MEMORANDUM

Re: 2022-TR 007 Rich's Car Wash (Pass Road and Abby Court, Biloxi MS)

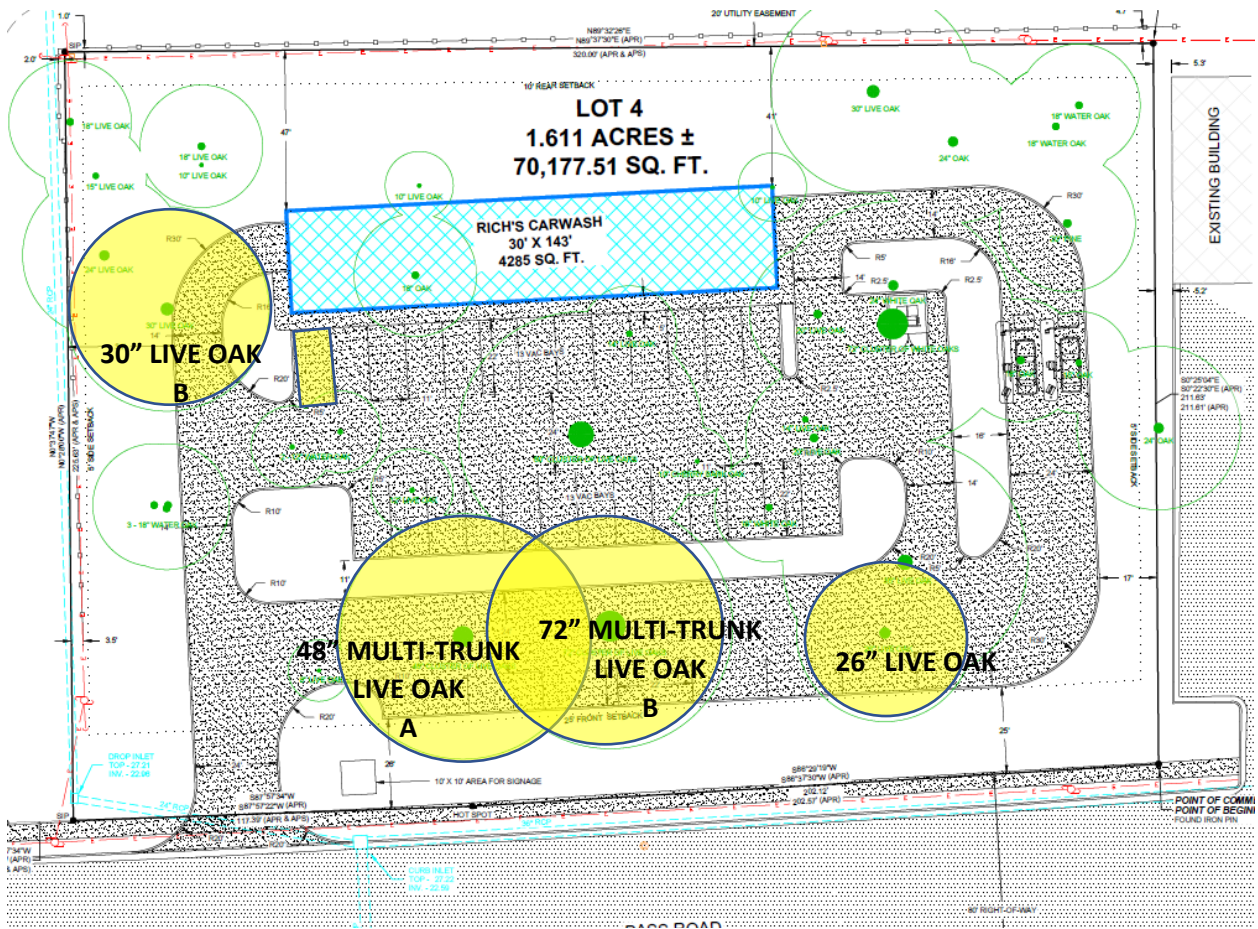
- 1) 3 of the 'clusters' are in fact very large multi-trunk live oaks (60", 72", and 48").
- 2) There are already multiple car washes on Pass Road.
- 3) Canopy and aesthetic on Pass Road is not satisfactory.

The project be revised to save the 30" Live Oak (A) on the north-western portion of the site in one of three ways:

- a) Moving the entire project 12" to the east and applying for a setback variance on the western boundary. Additionally, the drive would require permeable paving in the portion where the drive intersects with the tree canopy more than the allowable 10%.
- b) Rotating the project (clockwise) slightly and installing permeable paving at this point as described in (a), above.
- c) Removing one parking space and redesigning the car wash building to be 9' (feet) shorter than shown. This plan would eliminate the need for permeable paving since the drive would intersect with the tree canopy at a much lesser percentage.

The project be revised to maintain the important tree canopy along Pass Road (especially Cluster A and Cluster B shown above, and possibly Live Oak D) by:

- a) Eliminating the parking and drive that runs parallel to Pass Road.
- b) Moving the entry drive to the eastern side.
